Corps' Measures Workshop Public Comment Sheet

August 18th, 2008

Comment on Corps' Measures

Lower Basin Site Map

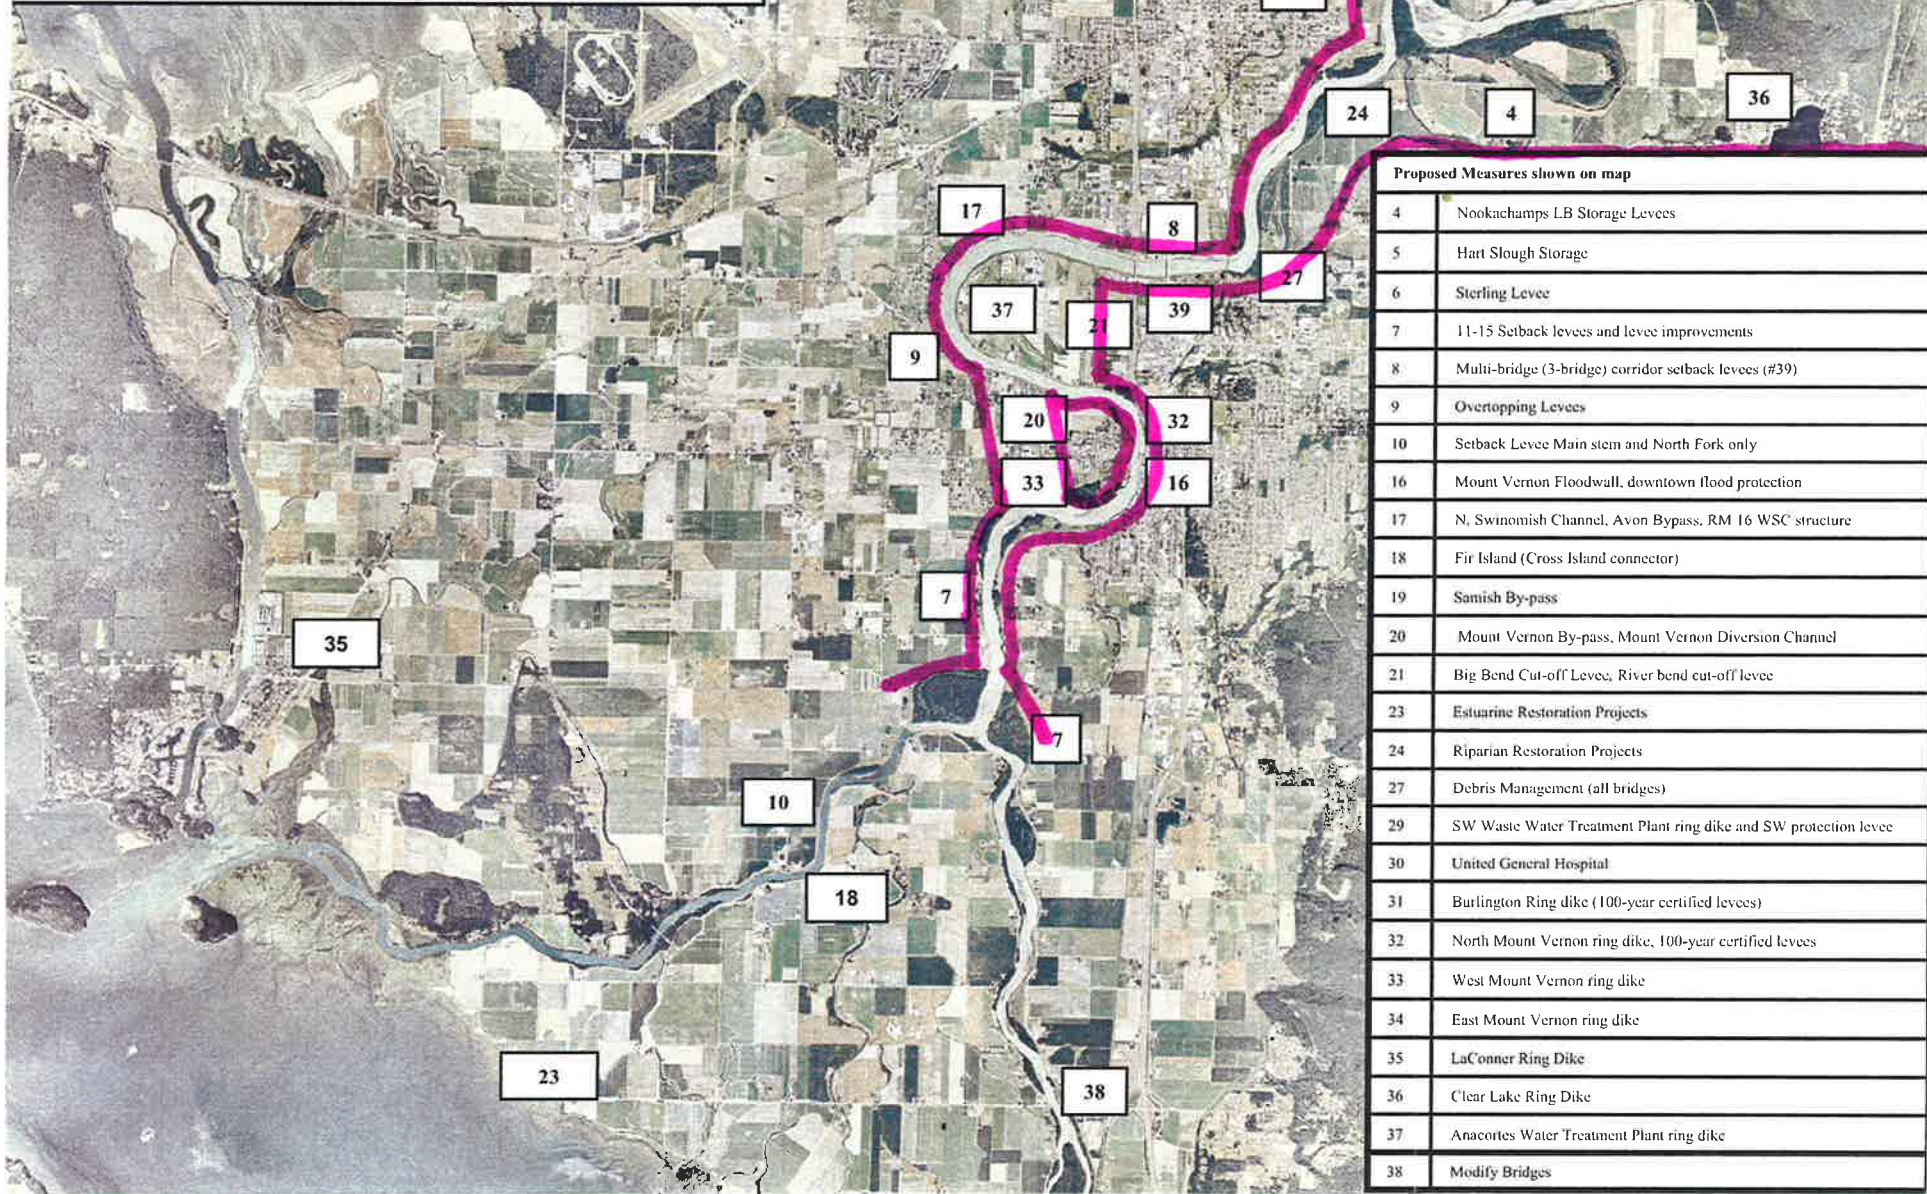
Measure number and name from Table 1.	Comment:
	What is the economic value of keeping I-5 open during 100 yr. flood?
Option A:	Widen 3 bridges corridor
Option B:	Move water under I-5 to the North.
	I like looking at Joe Leary because (slough) it is deep in spots and already is contained by Bayview ridge on the left bank.
